**Re: Downtown Heights Study and Official Plan Amendment  
Public Meeting, April 8, 2025 (Item 6.1)**

Urban Strategies Inc. is pleased to provide the following comments on the Downtown Heights Study and Proposed Official Plan Amendment (OPA). We are the planning and urban design consultant for the Wood Development Group, owner of the former Wood Plant No. 2 site in Downtown, which comprises the properties at 33 Elizabeth Street, 45 Elizabeth Street, 64 Duke Street, and 69 Huron Street. Following community engagement on a proposed development concept in the fall of last year, we are currently preparing an Urban Design Master Plan for the site.

Council Planning Meeting  
Proposed Official Plan Amendment: Downtown Building Heights  
April 8, 2025

Proposed modification to Schedule D

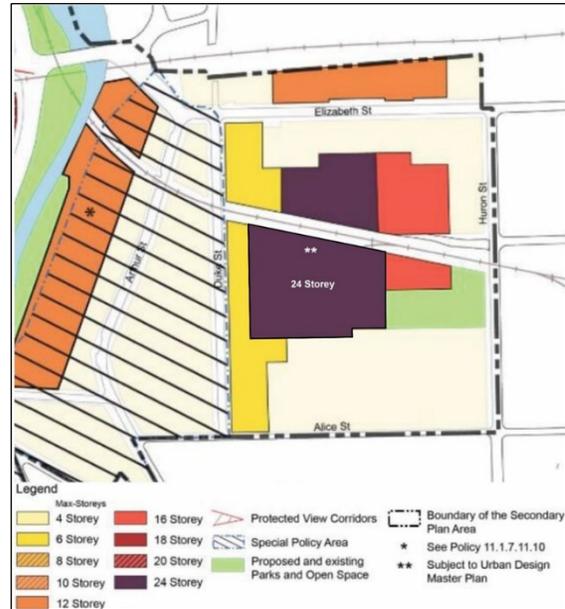
1. The delineation of maximum height zones on the Wood Plant No. 2 site—permitting up to 24 storeys in the heart of the site and up to 6 storeys along Duke Street and the site's south edge—supports the massing in our current concept in most respects. However, the delineation of the area south of the Guelph Junction Railway corridor for the tallest buildings does not fully capture a building currently proposed at 16 storeys and another at 9 storeys, as illustrated below. **We propose two potential refinements to the OPA, either of which would address our concern:**

As illustrated below, a slight expansion of the zone for up to 24 storeys on the south side of the Plant No. 2 site would allow for three residential buildings greater than 6 storeys to be accommodated south of the rail corridor with appropriate spacing.

#### **Recommended Schedule D Modification – Option 1**
